**RESPONSE TO COMMENTS  
NPDES PERMIT NO. MA-NHG580000  
SMALL WASTEWATER TREATMENT FACILITIES GENERAL PERMIT  
MODIFICATION**

In accordance with the provisions of 40 Code of Federal Regulations (CFR) §124.17, this document presents EPA's responses to comments received on the Draft NPDES General Permit # MA-NHG580000 ("Draft General Permit"). The Response to Comments explains and supports EPA's determinations that form the basis of the Final General Permit. From October 27, 2022 through January 25, 2023, EPA solicited public comments on the Draft General Permit.

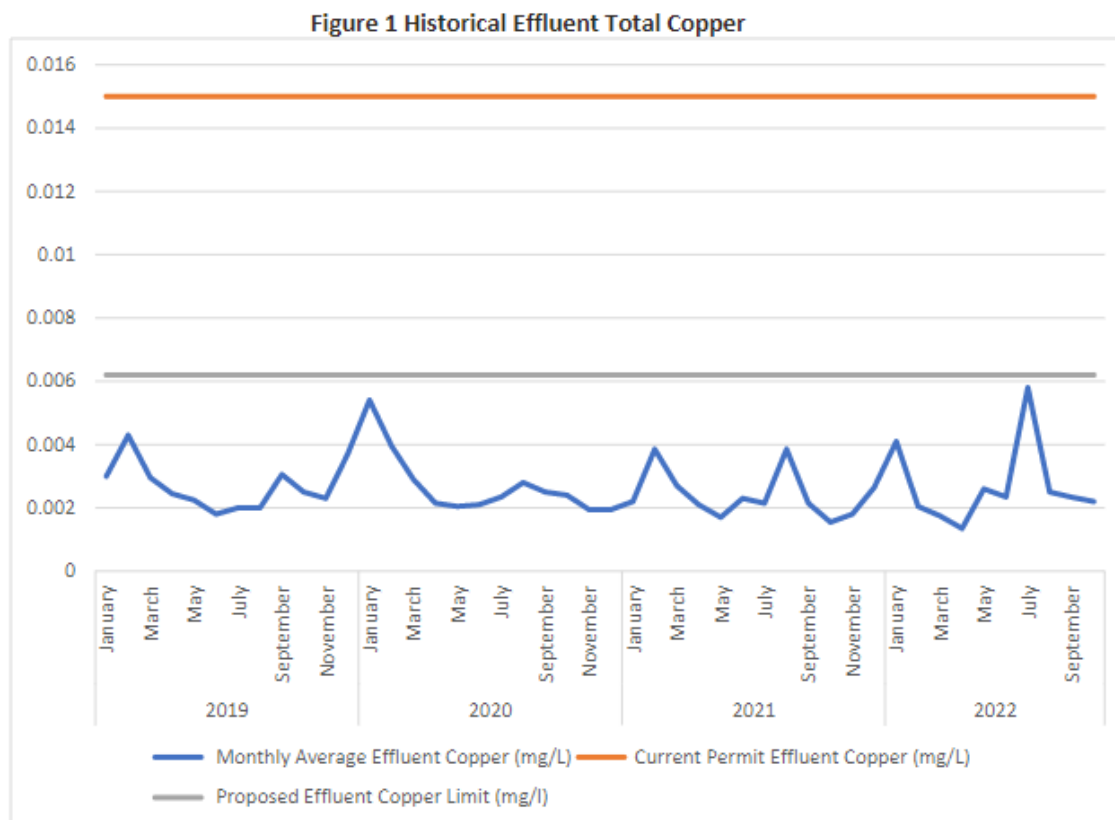
The new draft permit includes a reduction in effluent Ammonia-Nitrogen from 15.7 mg/l to 4.4 mg/l with an increased monitoring frequency from one (1) time per week to two (2) times per week. To consistently meet the new ammonia limit in the draft permit, the Town will need to upgrade the existing facility from an aerated lagoon facility to an activated sludge process. This is in addition to needing to upgrade the facility to consistently meet the new metals limits. The Town is committed to a planning study in 2023 with a bond vote in 2024 to obtain funding approval to advance with design and construction of a major facility upgrade.

EPA acknowledges this comment and appreciates the Town's efforts to ensure continued compliance with this more stringent ammonia limit.

Based on this comment, EPA reviewed the ammonia effluent data during the review period and found that there were 25 monthly average values as presented in Appendix A of the 2022 Statement of Basis. EPA notes that five of these 25 samples exceeded the proposed limit of 4.4 mg/L and the 95<sup>th</sup> percentile value of the effluent dataset was 8.8 mg/L. Therefore, EPA considers it appropriate to include an 18-month compliance schedule for ammonia in accordance with the terms of Part IV.E.1 of the General Permit. This 18-month compliance schedule is appropriate given that it was designed for "any newly established or more stringent water quality-based effluent limits which EPA has determined the Permittee is not expected to be in compliance with upon the effective date of the General Permit." Part IV.E.1 of the Final General Permit has been updated accordingly to include Pittsfield's more stringent monthly average ammonia nitrogen limit.

Should the Town need additional time to comply with this limit, they are welcome to contact EPA's Enforcement and Compliance Assurance Division (ECAD) to discuss the possibility of a compliance schedule through an administrative order.
